# Village of Arlington Heights Building & Life Safety Department

**To:** Sam Hubbard, Development Planner, Planning and Community Development  
**From:** Deb Pierce, Plan Reviewer, Building & Life Safety Department  
**Subject:** 519 W Algonquin Rd. – Land Use Variation – European Crystal Hotel  
**PC#:** 18-021 – Round 1  
**Date:** November 15, 2018

**PLAN COMMISSION PC #18-021**  
**European Crystal LUV Amendment**  
**519 W Algonquin Rd**  
**Amendment to Land Use Variation for Hotel, Parking Variation**  
**Round 1**

Project: European Crystal Hotel LUV Amendment – James Cazares  
519 W. Algonquin Road

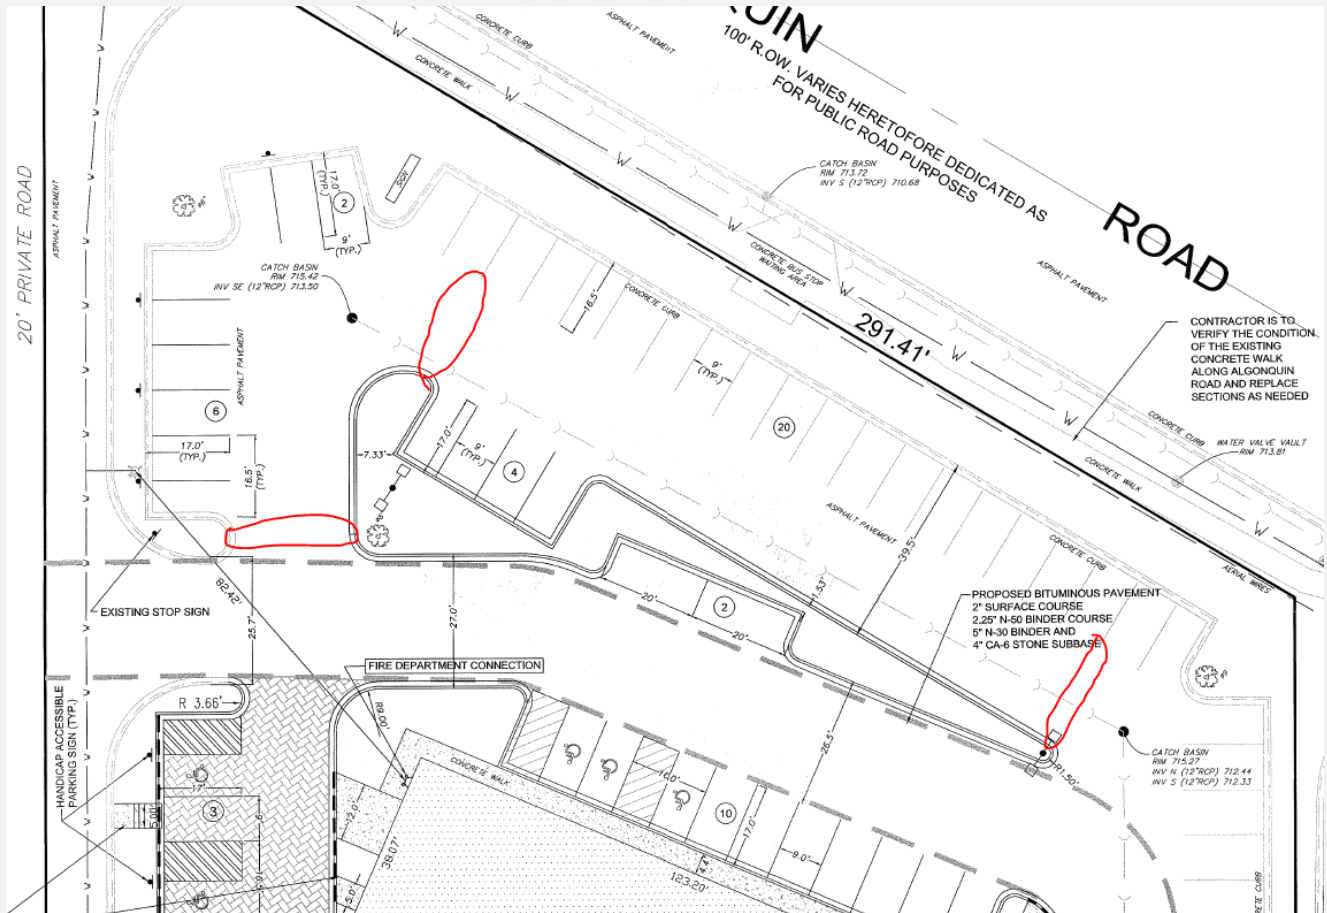
23. Please provide a dimension for the northern drive aisle in the following locations:

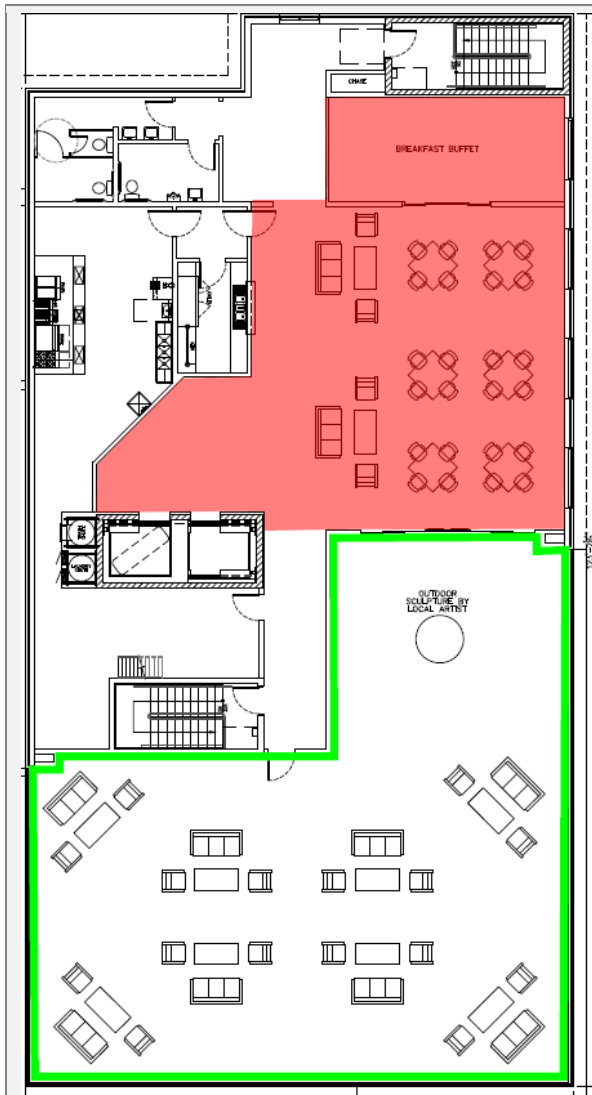
24. Please revise the floor plan to include a dashed line outlining the two areas shown in the drawing on the next page (both red and green) and calculate the sizes (in square feet) of each of the two areas indicated/highlighted in the drawing:
